Research Reactor Center

February 7, 1995

REFERENCE: Docket 50-186
University of Missouri Research Reactor
License R-103

SUBJECT: Requested Change to University of Missouri Research Reactor Facility
License No. R-103

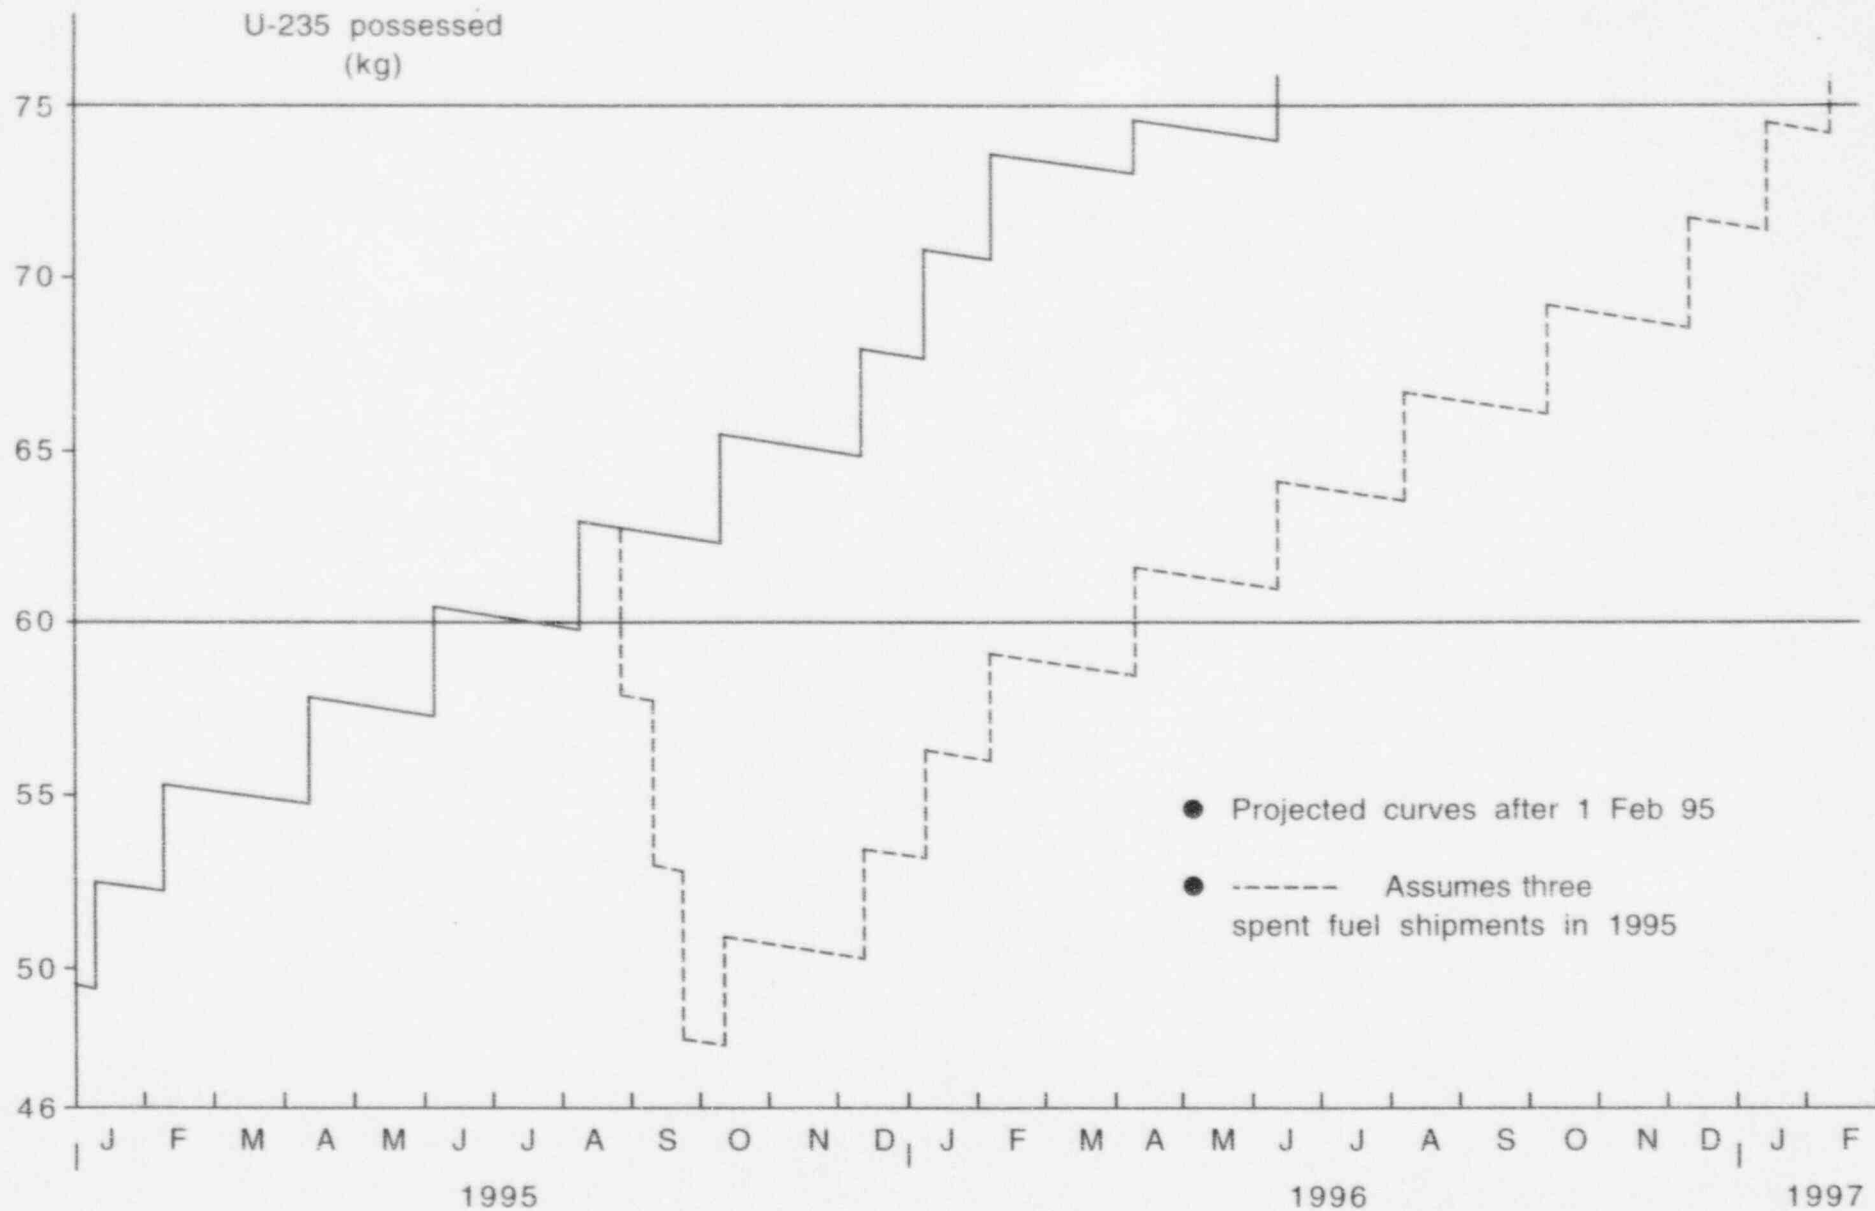
Our present 60 kilogram temporary possession limit (License Amendment No. 26) expires May 31, 1995. The attached graph (dashed line) shows that even if we make three spent fuel shipments, as tentatively scheduled, we will not be able to get below our historic 45 kilogram uranium-235 possession limit. For the foreseeable future, until we are able to resume more regular and increased spent fuel shipments to reduce the backlog of elements stored at MURR, we anticipate the possessed uranium-235 will vary between 40+ and 60 kilograms.
